Memorandum

SUBJECT: Wyoming Classical Academy – Commercial Site Plan
Lot 1, Mountain Meadows No. 2, Town of Mills

Case Number: 23.01 SKC

Site Plan/Development Plan

**MILLS CHARTER SCHOOL
DRAINAGE PLAN**

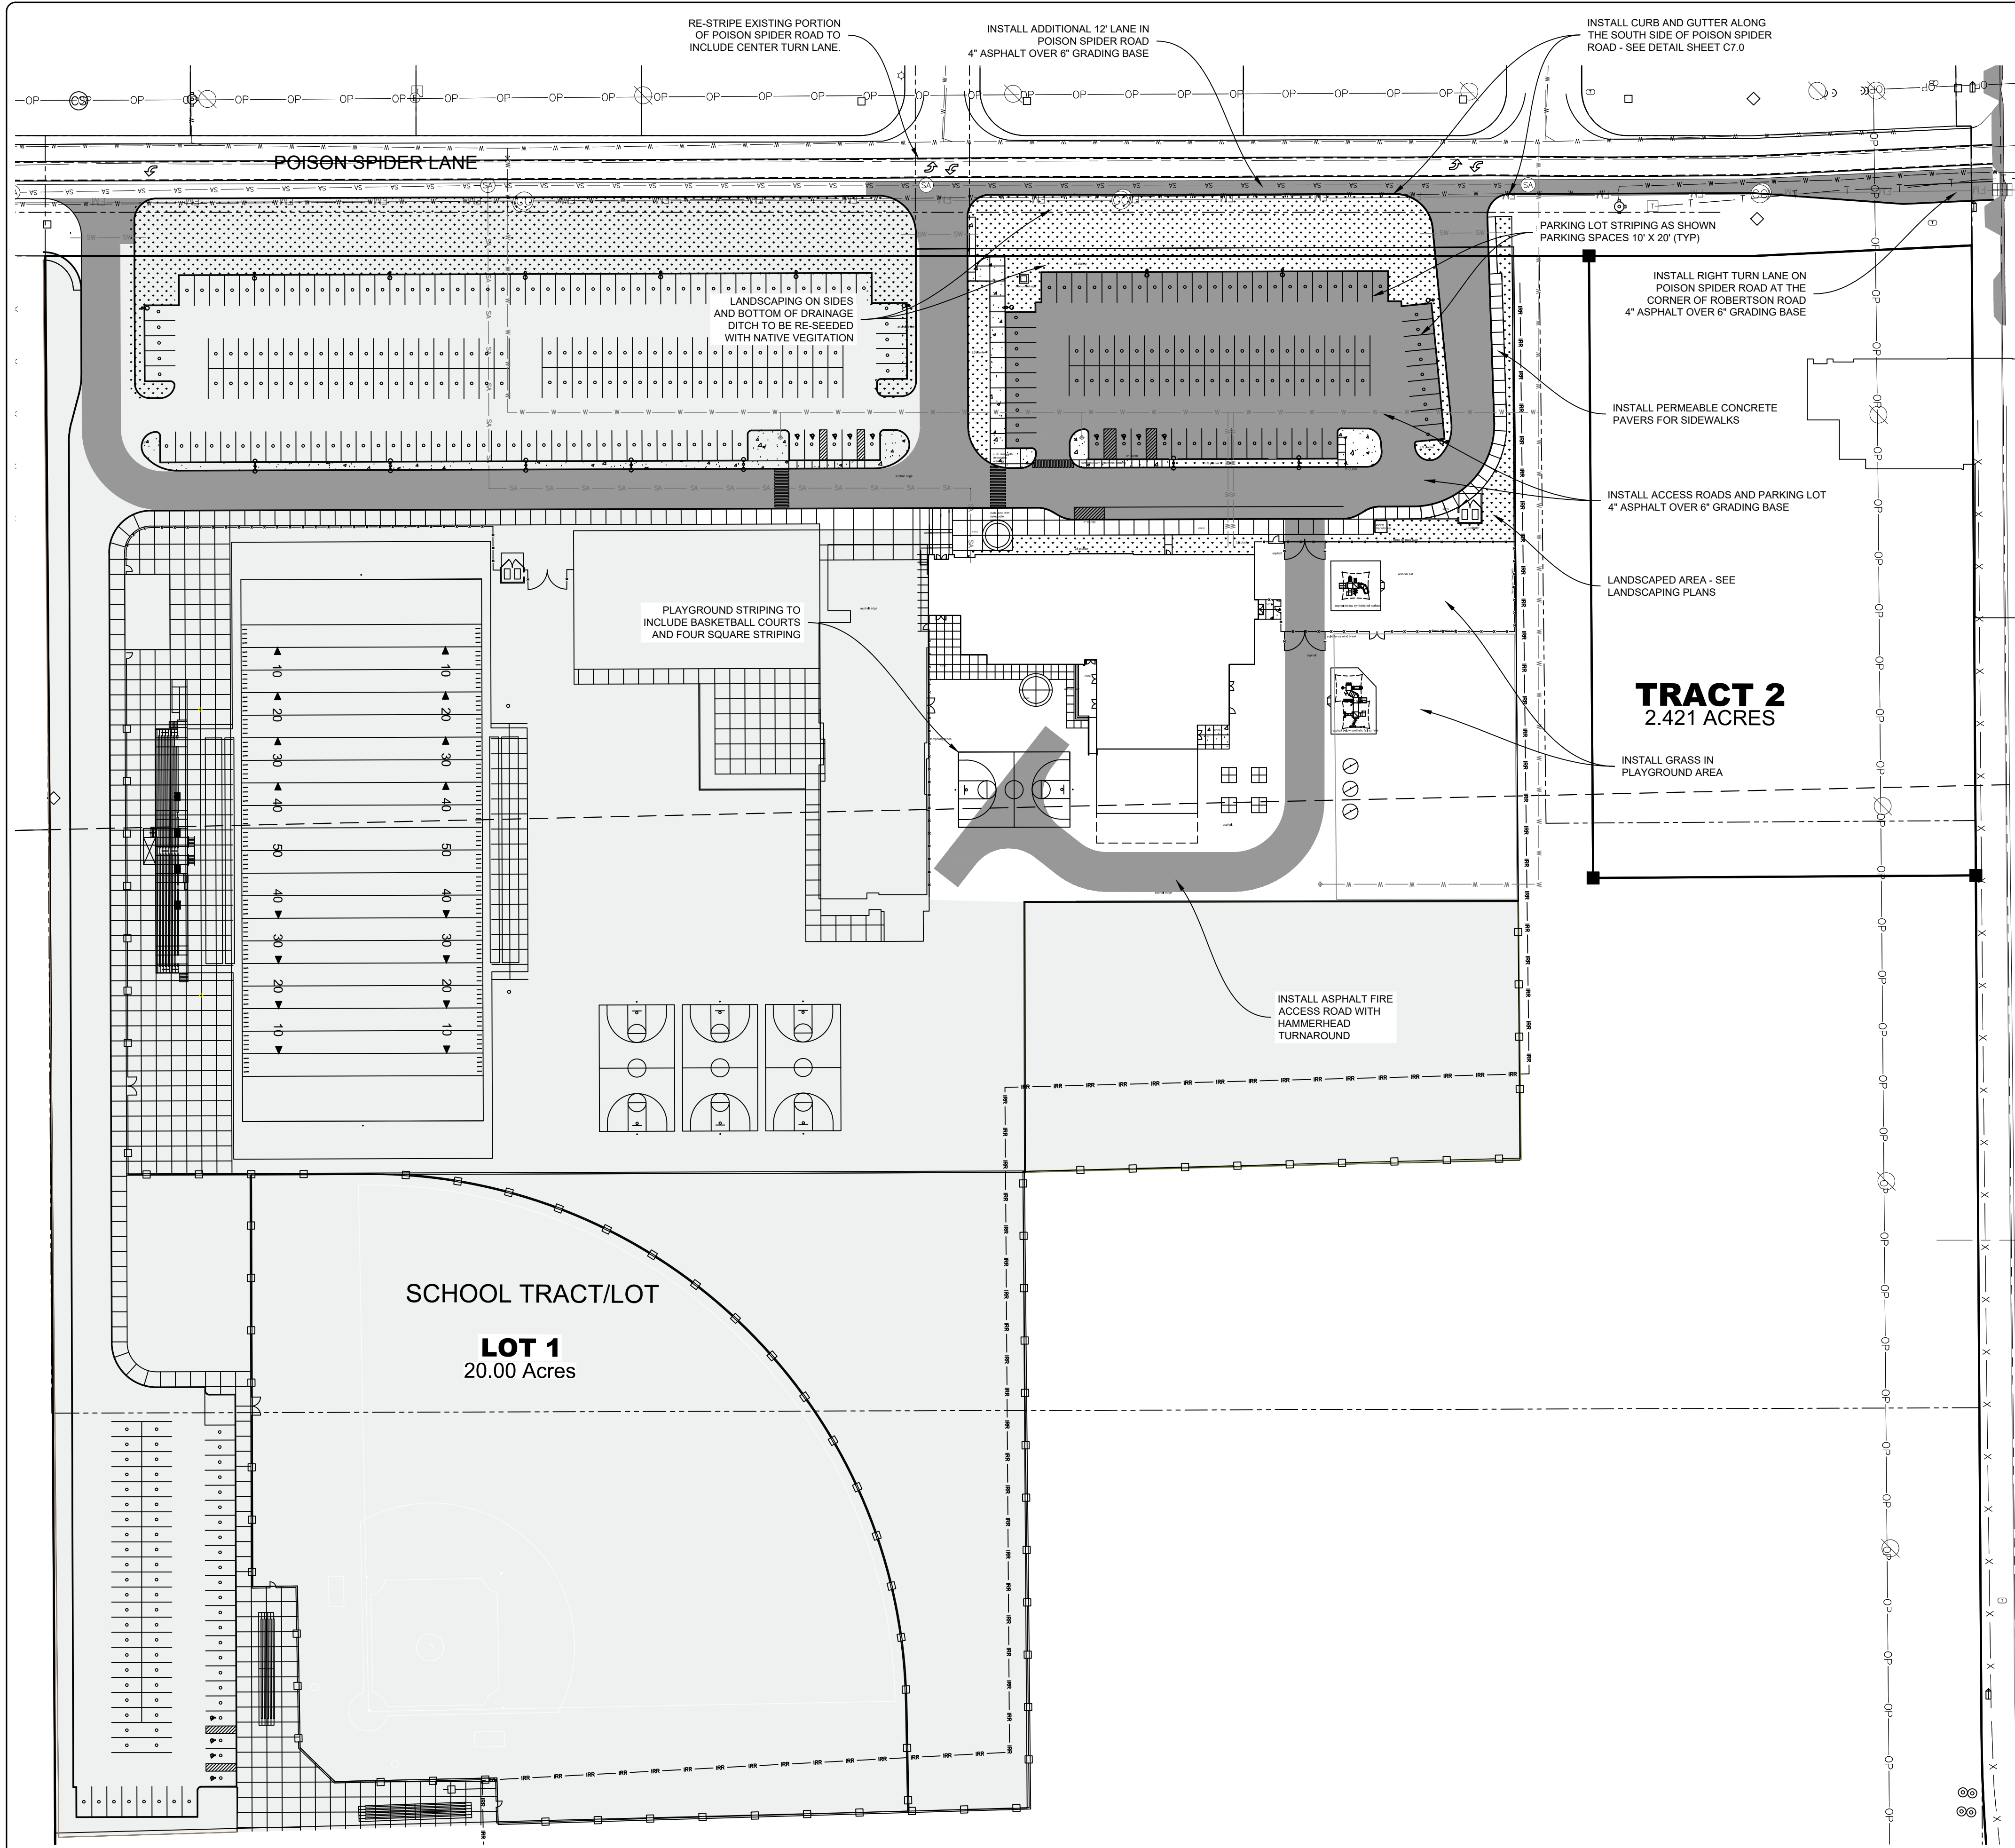
Member Volzke then inquired about drainage on the site was going to work, as he is very familiar with the area and knows that some of the homes on the same side of the road as the school cannot have basements because of the level of ground water in the area. He wondered what the plan was to address this.

Mr. Gustafson stated that a full drainage study was done for the drainage basin when the Platte View Estates subdivision was constructed. The ditching system in place takes all the water to the west and dumps it into a detention pond that is currently oversized. With the school being added to other elements included in the study, there is still enough room within the drainage system to accommodate the impact of the school. The detention pond was sized adequately so that future development could occur without the need to expand the drainage pond.
